Re Indian Point Unit No. 3
Docket No. 50-286

Paragraph 3.3.A.3 of the proposed full-power Technical Specifications transmitted to you by letter dated January 29, 1976 identifies certain valves (744, 842, 843, 856B and G, 882, 894A, B, C & D, and 1810) which must be de-energized in order to meet the single failure criterion.

A listing of those electrical schematics affected by these changes is delineated in Attachment A. Forwarded herewith are seven (7) copies of finalized versions of those schematics listed in Attachment A.

ATTACHMENT A

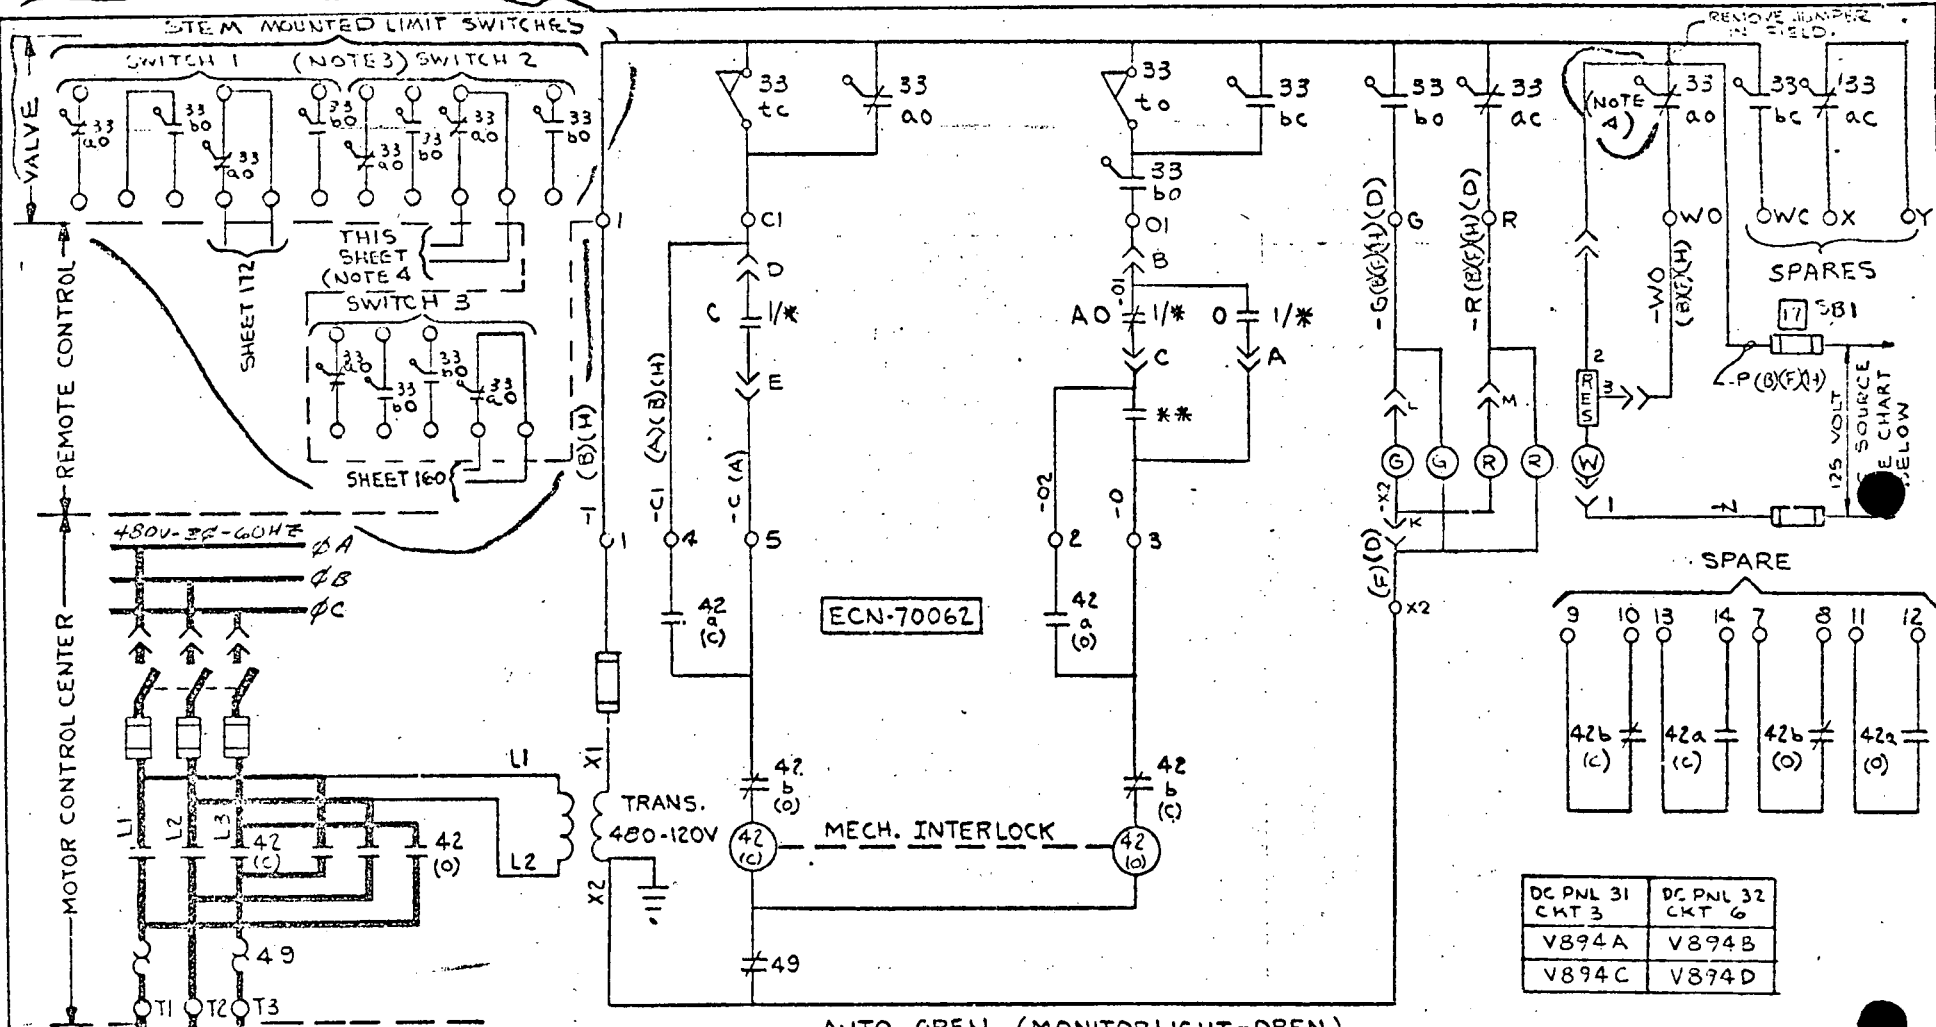
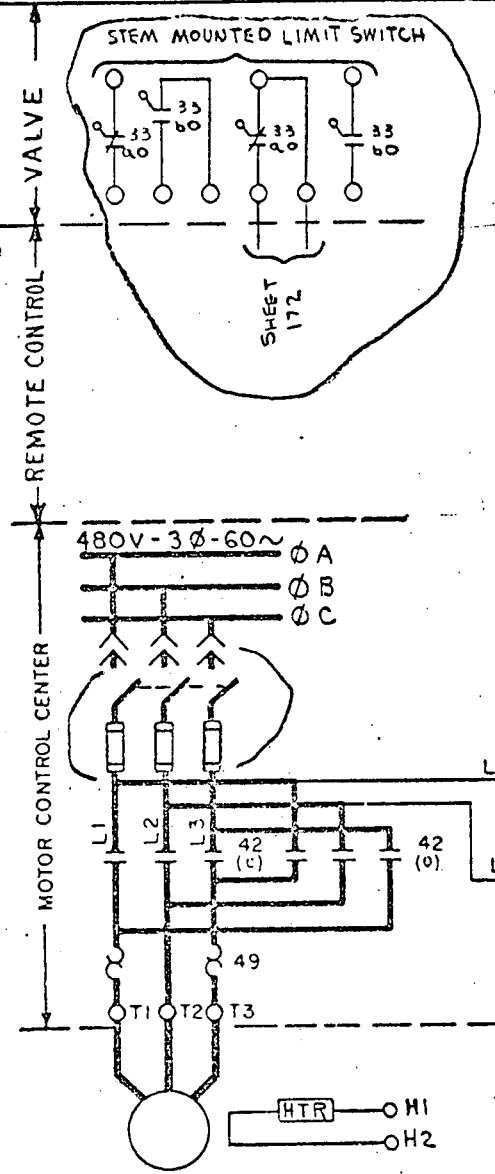
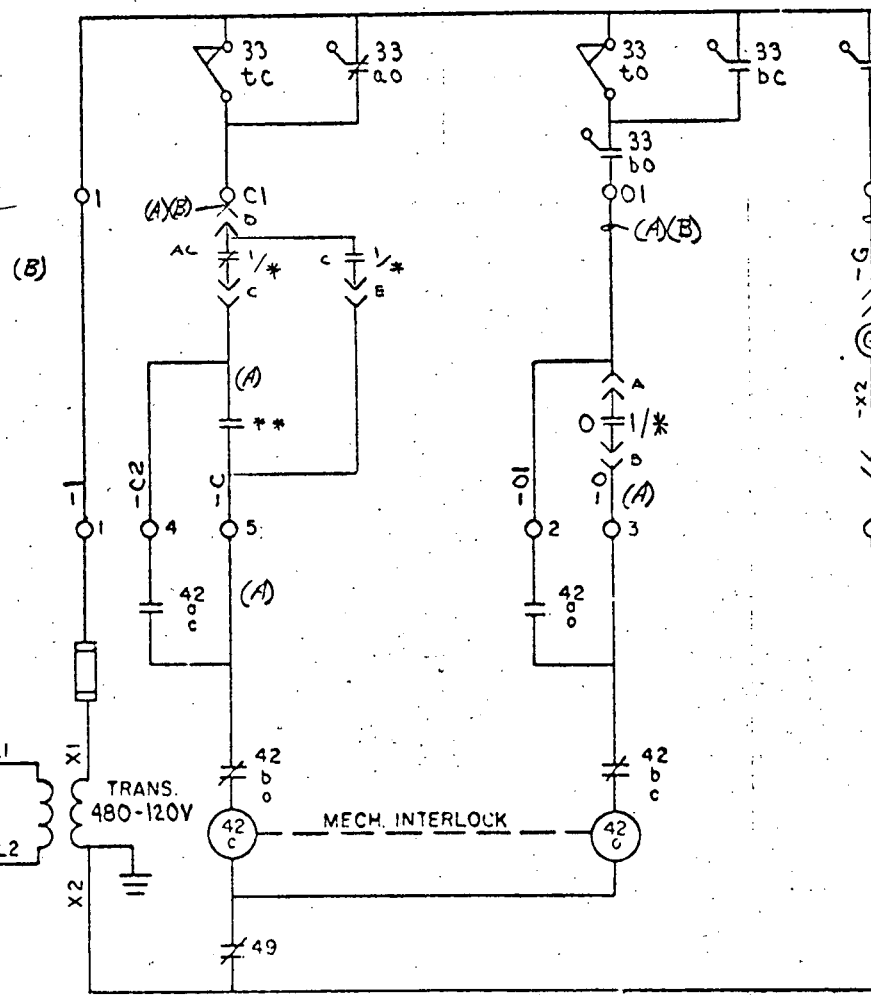
In addition, since the operator for Valve 894C is assumed to be submerged following a postulated loss-of-coolant accident, both its existing bright/dim white light circuit and annunciator alarm circuit which provides audible indication will be disconnected from the valve operator and reconnected to new limit switches mounted above the calculated water level (El. 50'-1½") inside containment. The limit switch for the new status light system is also mounted above the calculated water level. These new limit

4. USE 3340 ON STEM MTD. LIMIT SW. #2 FOR VLV. 894C.

- NOTE:
1. WIRE DESIGNATIONS ARE TO BE PREFIXED WITH VALVE NO.
 2. LETTER (A) ETC. REFERS TO CABLE SCHEMATIC.
 3. STEM MOUNTED LIMIT SWITCH #2 AND #3 ON VALVE 894C ONLY.
